UNITED STATES PATENT AND TRADEMARK OFFICE

| APPLICATION NO. | FILING DATE | FIRST NAMED INVENTOR | ATTORNEY DOCKET NO. | CONFIRMATION NO. |
|-----------------|-------------|-----------------------|---------------------|------------------|
| 09/609,868 | 07/03/2000 | Kenneth Gordon Walker | W2450002 | 3798 |

Office Action Summary

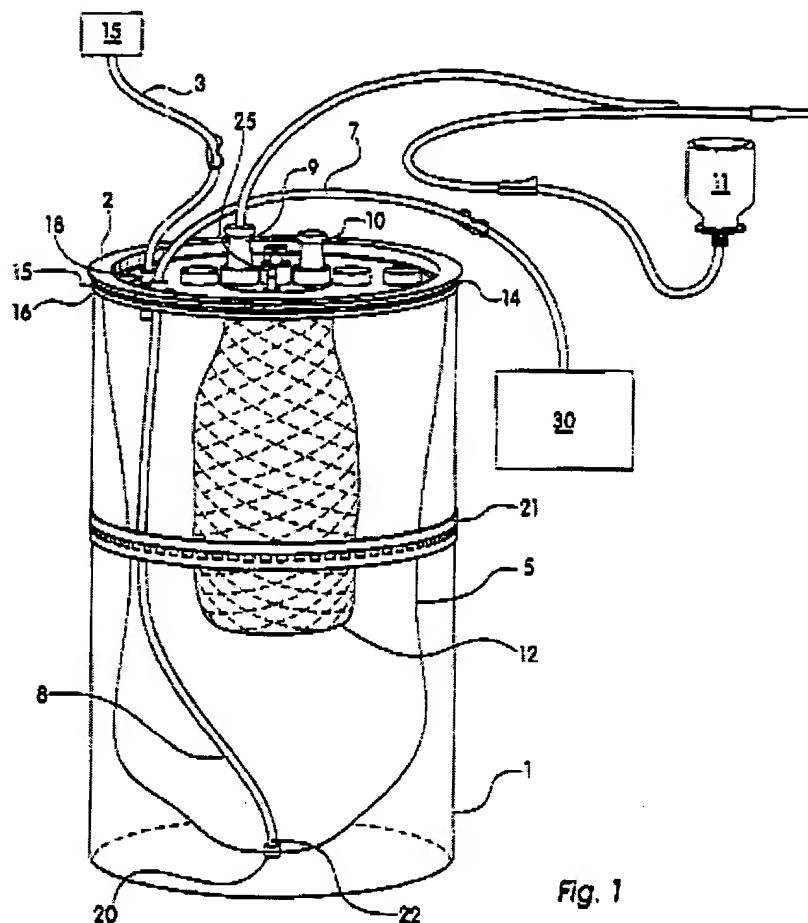
Regarding claim 31, *Schneider* teaches a lid (2) for covering a canister body (1), said lid (2) and canister body (1) together forming a canister for receiving fluids, said canister body (1) having side walls and a bottom, said lid (2) comprising:

an inlet port (9) in said lid (2) for inflow of fluids into said canister;

an outlet port in said lid for outflow of fluids from said canister;

a conduit (8) in fluid communication with said outlet port, said conduit (8) extending to the bottom of said canister body (1) when said lid (2) is placed in covering relation to said canister body (1); and

a vacuum port (18) in said lid (2) for application of vacuum to said canister for inducing flow of fluids into said canister (*see* Fig. 1, below).

It is noted that outlet port is the point in the lid (2) where the outlet tubes (7, 8) meet. It is further noted that parent application No. 09/394,282 to *Schneider* has been reviewed by the examiner and supports all of the elements used in this rejection.

Regarding claim 36, *Schneider* teaches a suction canister, comprising:

a chamber for receiving fluids (1), said chamber being partially defined by a bottom wall;
an inlet (9) communicating with said chamber for the inflow of said fluids into said chamber;

a vacuum port (18) communicating with said chamber for application of vacuum to said chamber;

an outlet communicating with said chamber for outflow of said fluids from said chamber;
and

a conduit (8) in fluid communication with said outlet and extending to said bottom wall of said chamber (*see* Fig. 1, below).
